SERVICE BULLETIN

92MY SIA BUILT LEGACY STATION WAGON
WITH MANUAL TRANSMISSION

SUBJECT: COMBINATION METER WIRING

Relocate the pins in connectors I-14 and I-15 as shown

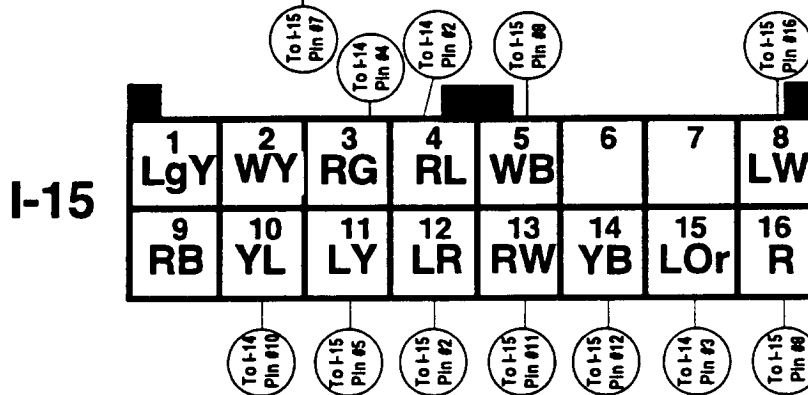
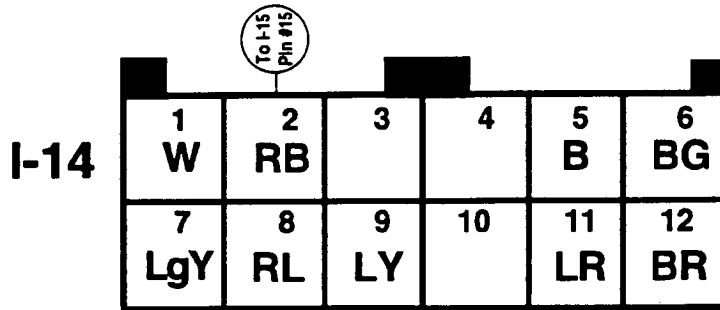
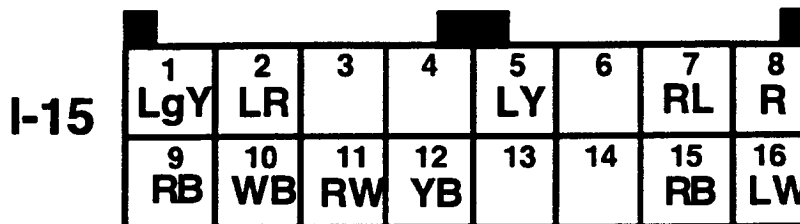
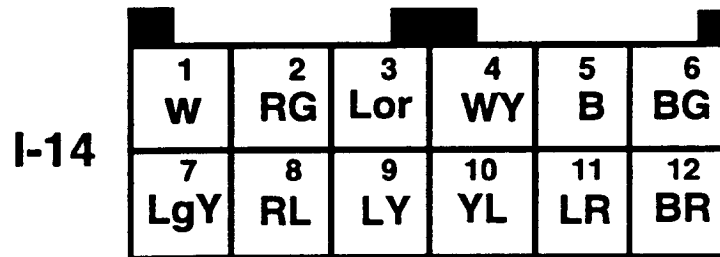
If you receive a manual transmission Legacy station wagon with the following condition:

- o Rear gate telltale light "on" all the time and will not turn-off with gate latch adjustments and no wiring problems are found at the rear gate harness.
- o Side door telltale lights are inoperative.

The connectors may be incorrectly wired for an automatic transmission. Use the schematic in Figure 1 to relocate the pins in connectors I-14 and I-15 to convert the harness to a manual transmission configuration.

Note: I-14 is not used on manual transmission Models
